CONSTRUCTION COMPLETION REPORT  
FOR SEAD-16 AND SEAD-17  
SENECA ARMY DEPOT ACTIVITY

FOR THE ABANDONED DEACTIVATION FURNACE (SEAD-16)  
AND THE ACTIVE DEACTIVATION FURNACE (SEAD-17)  
SENECA ARMY DEPOT ACTIVITY

**Subject:** Response to USEPA Comments dated 021208  
Draft Construction Completion Report for SEAD-16 and SEAD-17  
Seneca Army Depot  
Romulus, New York

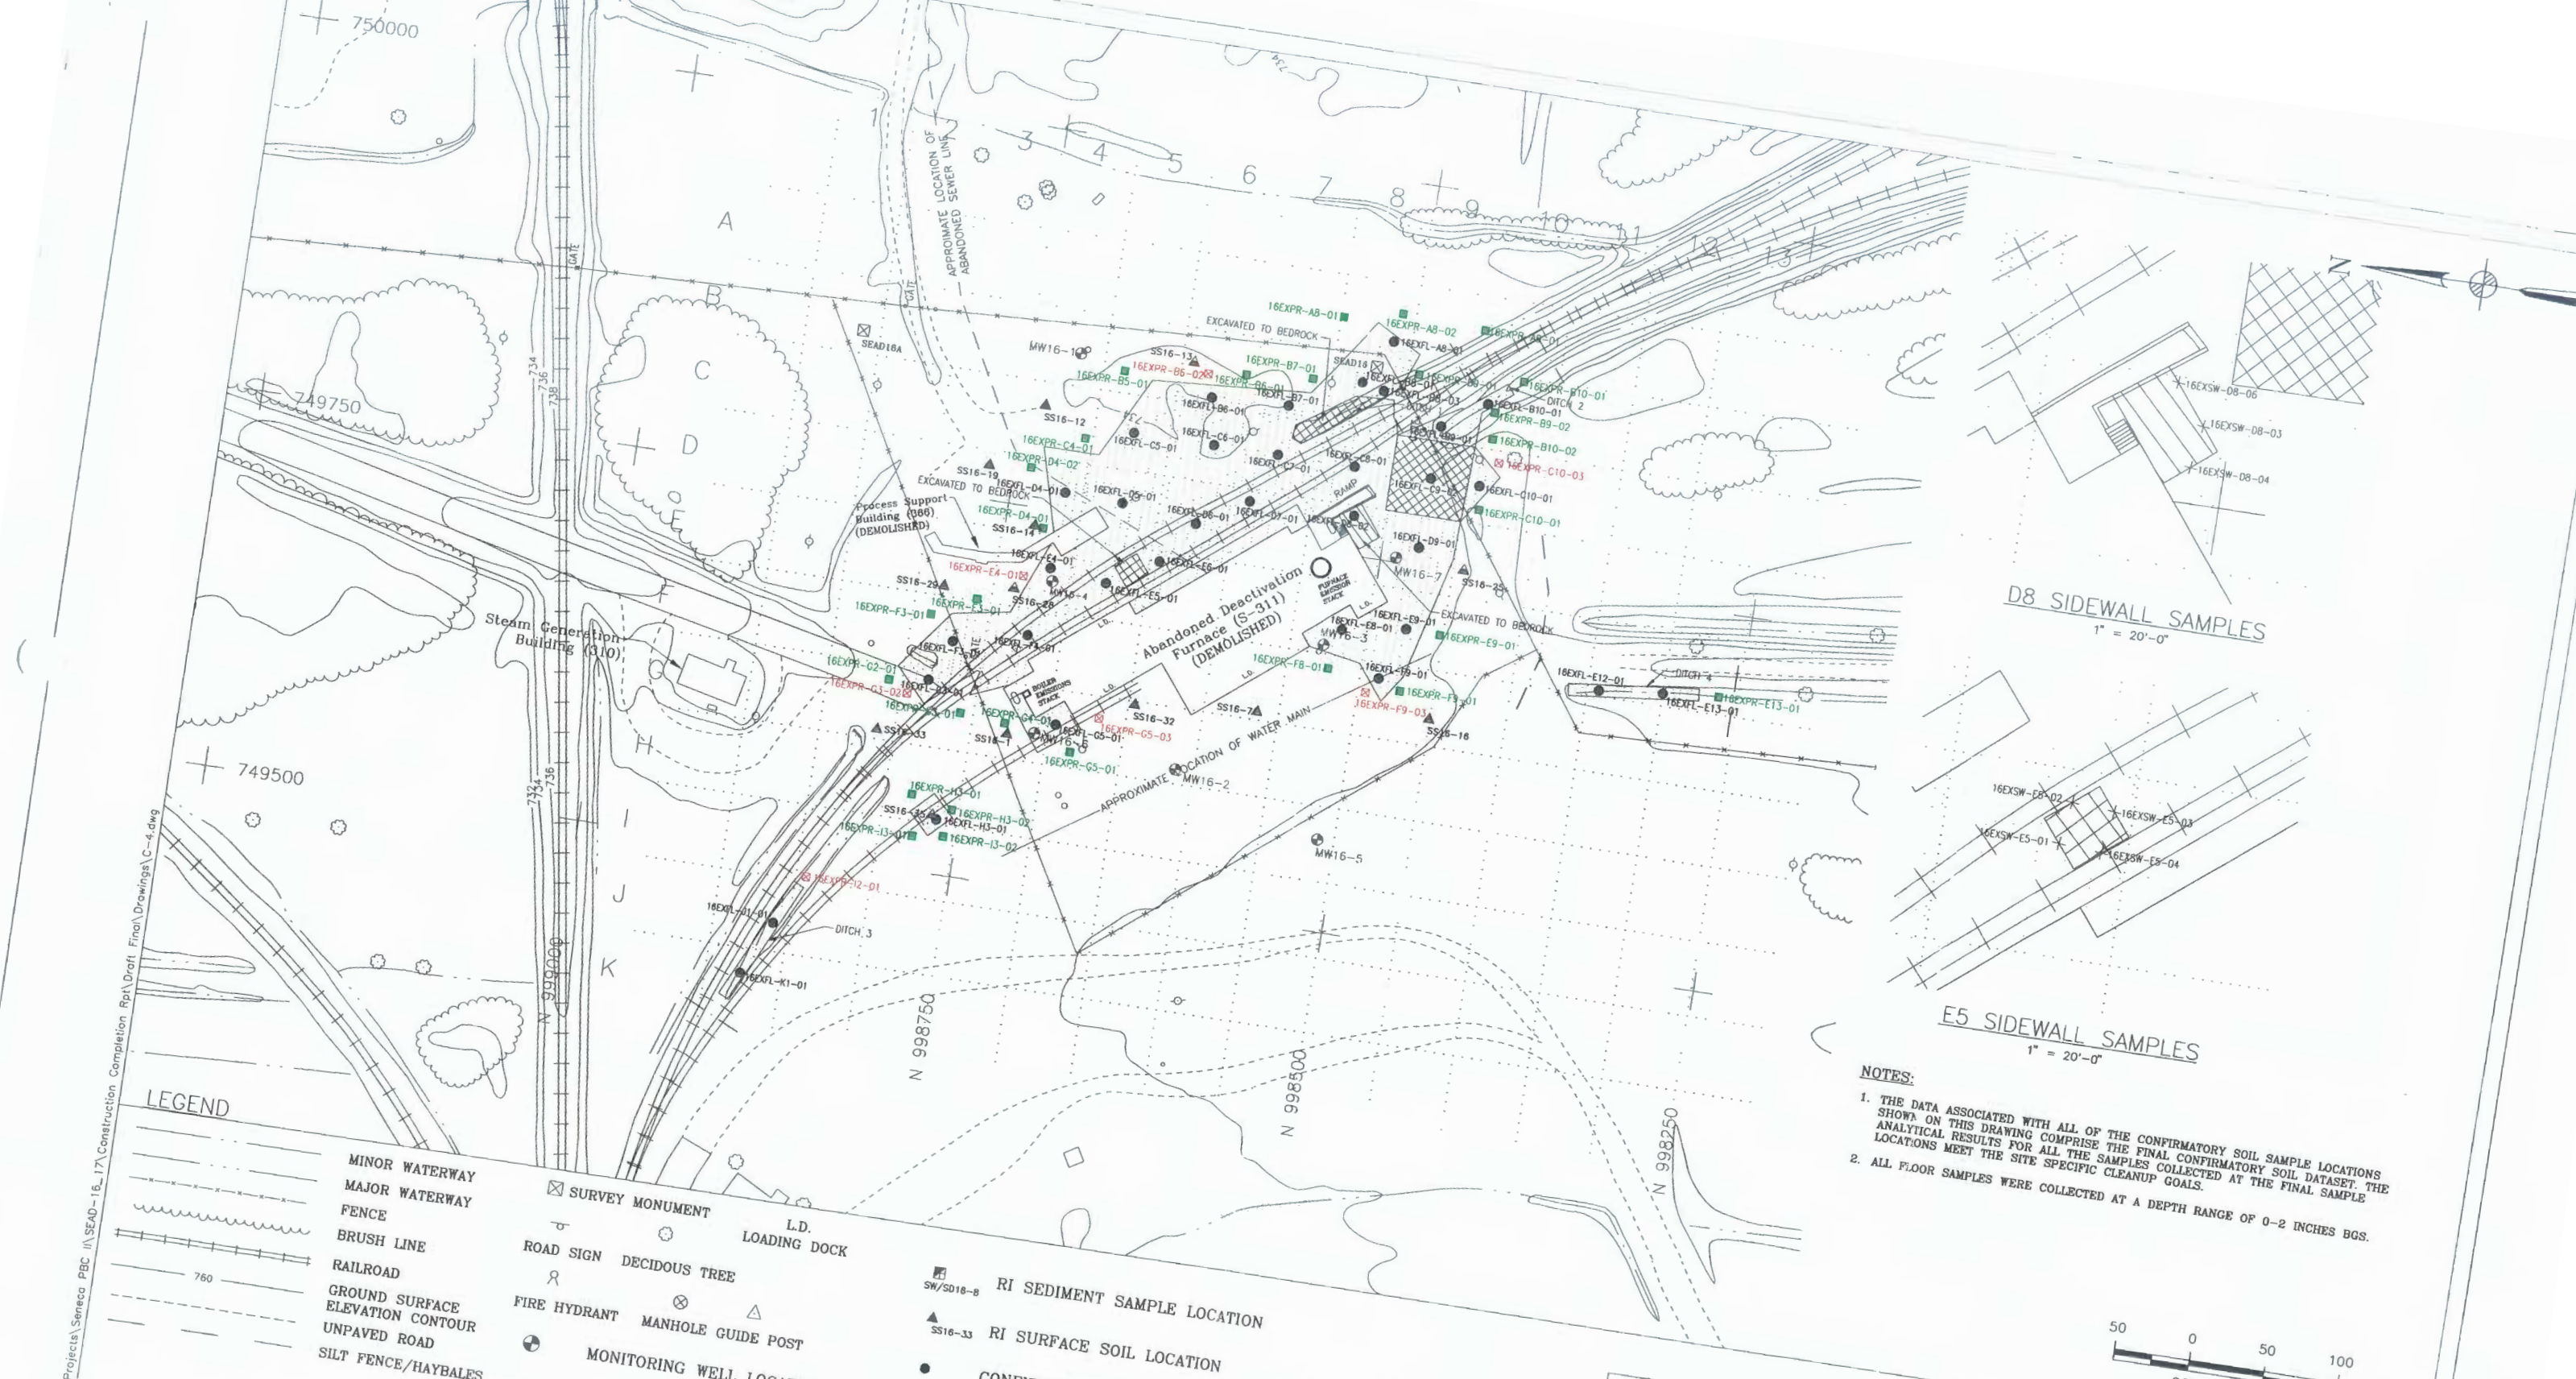
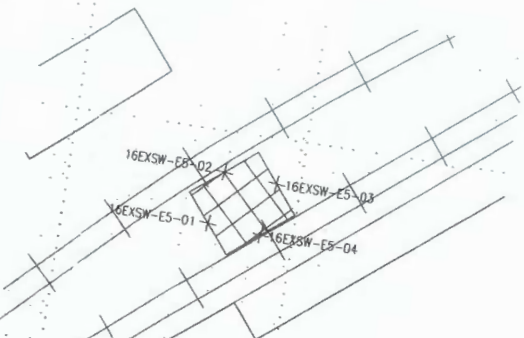
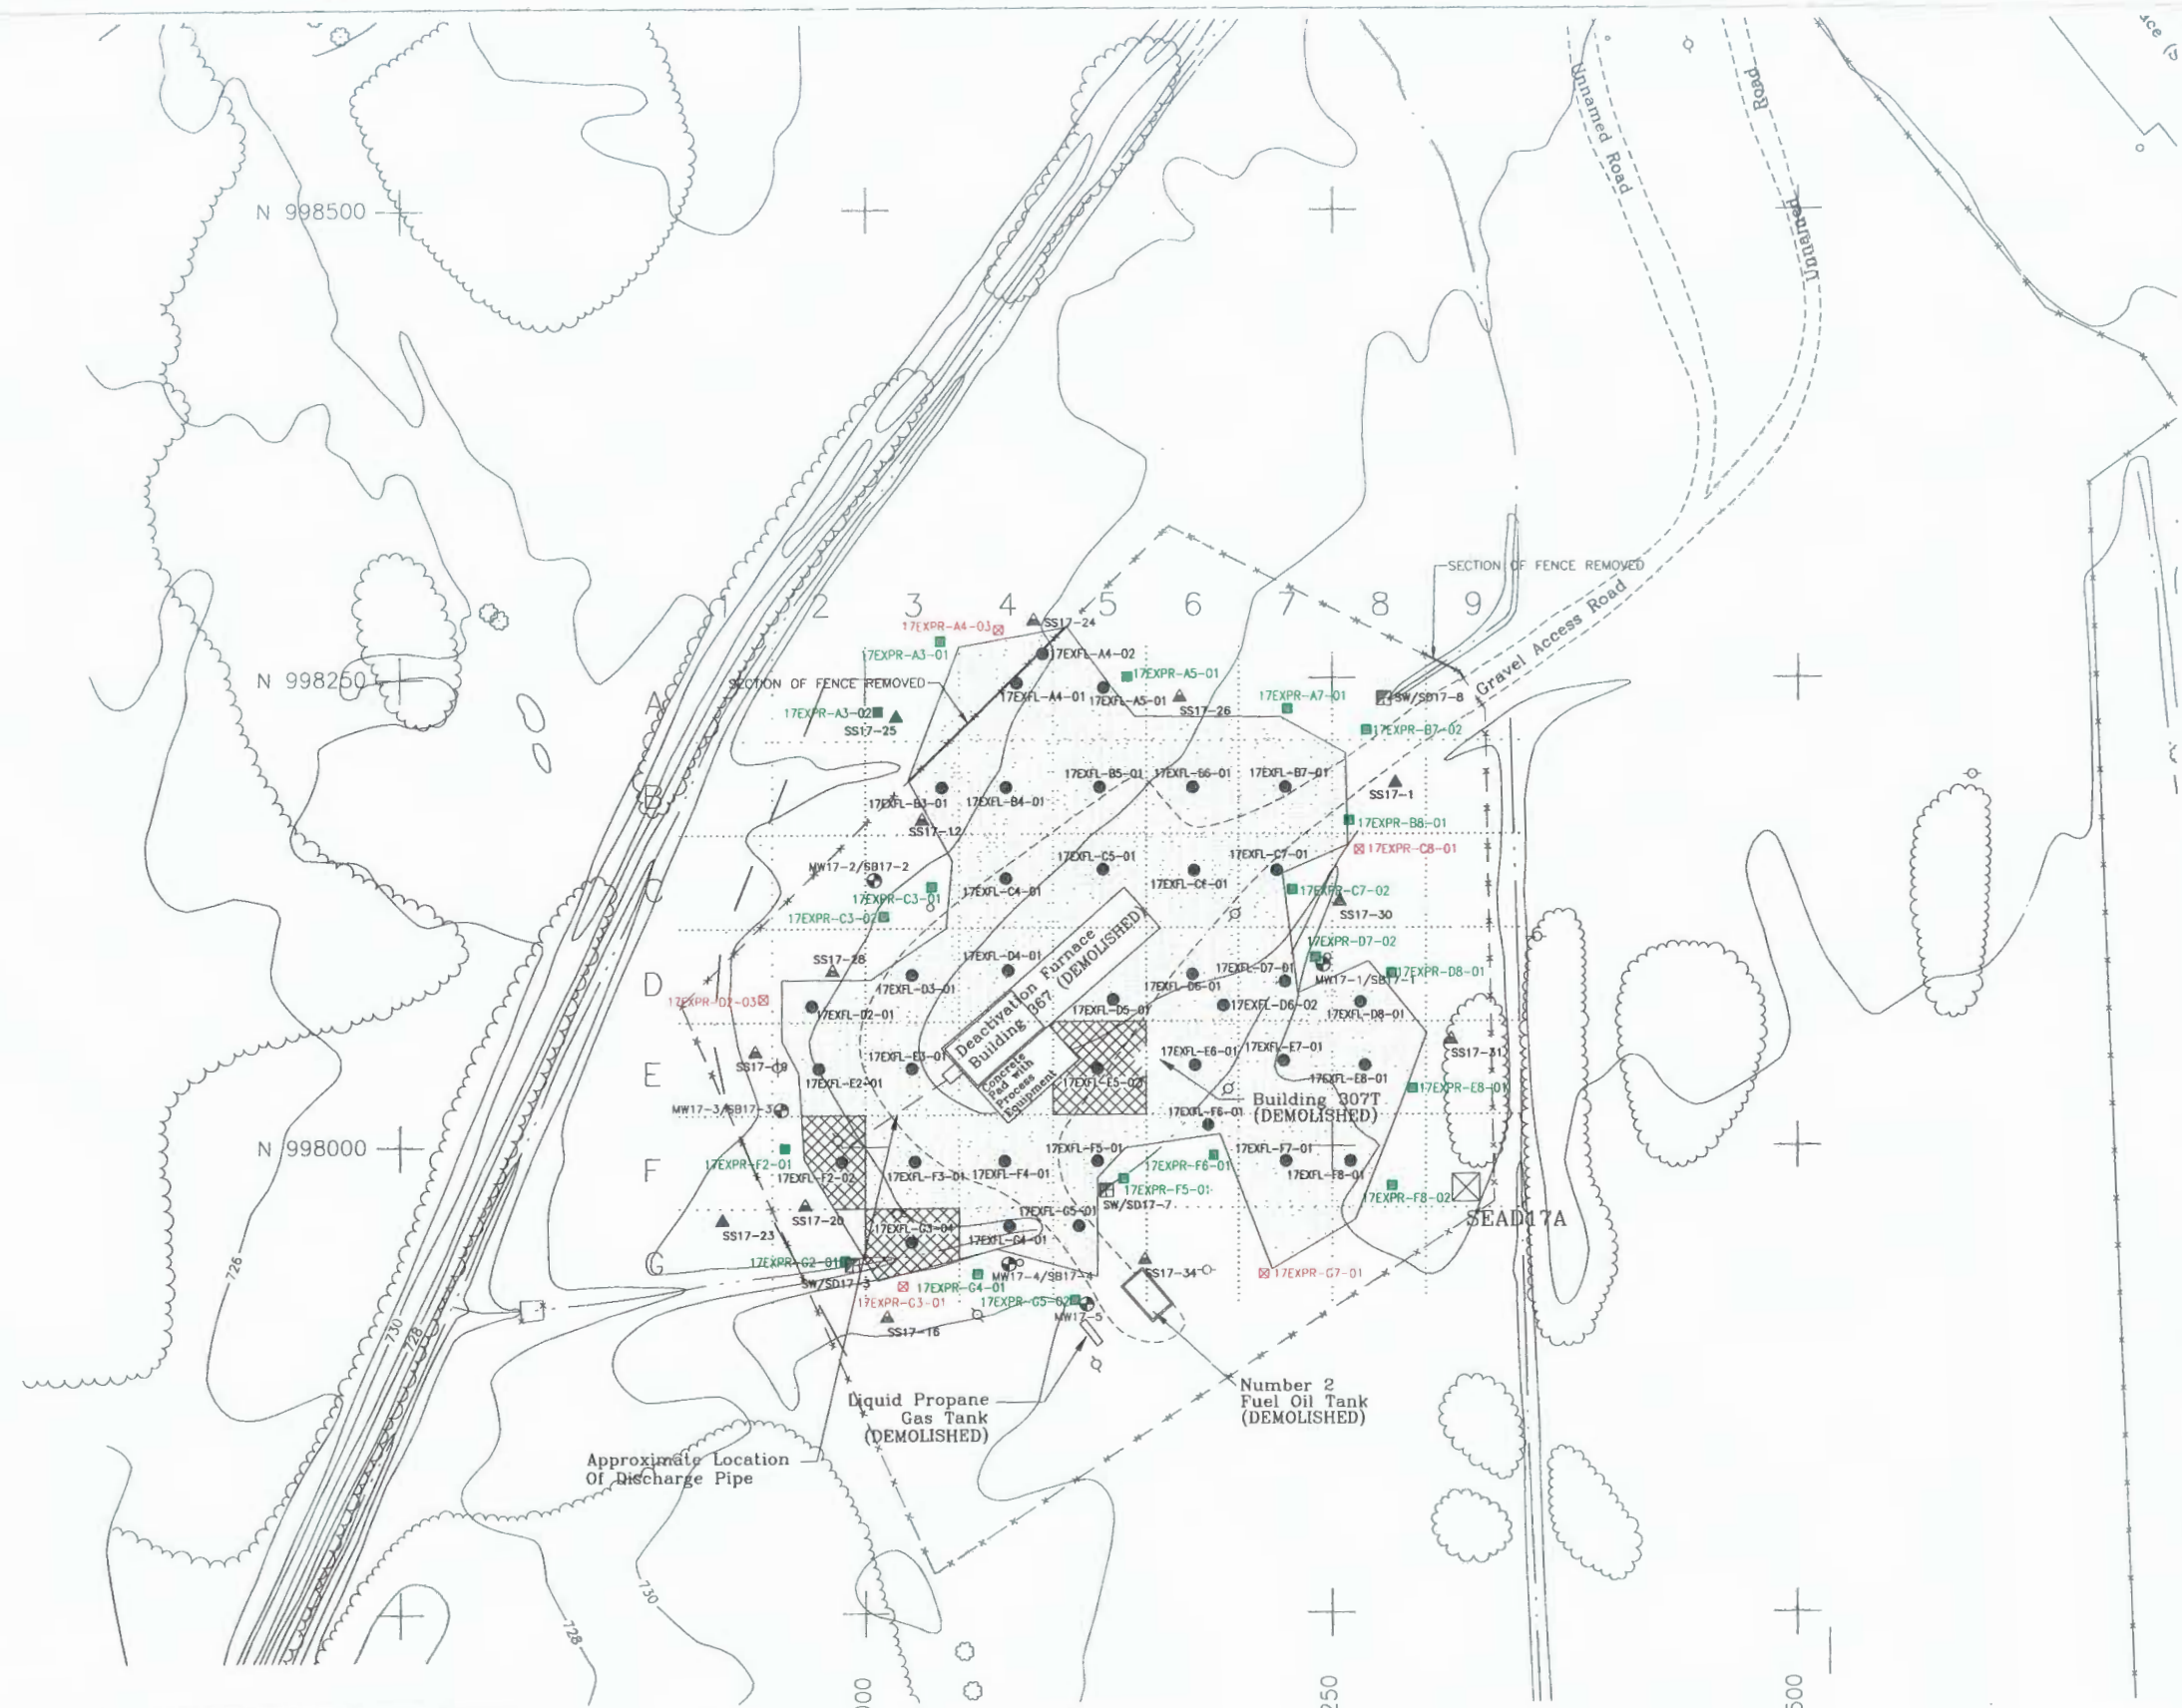
**Comment 7:** The confirmation floor samples collected from the excavated grids are not labeled on figures C-4 and C-5. Revise figures to include sample IDs similar to perimeter and side wall samples for consistency and clarity.
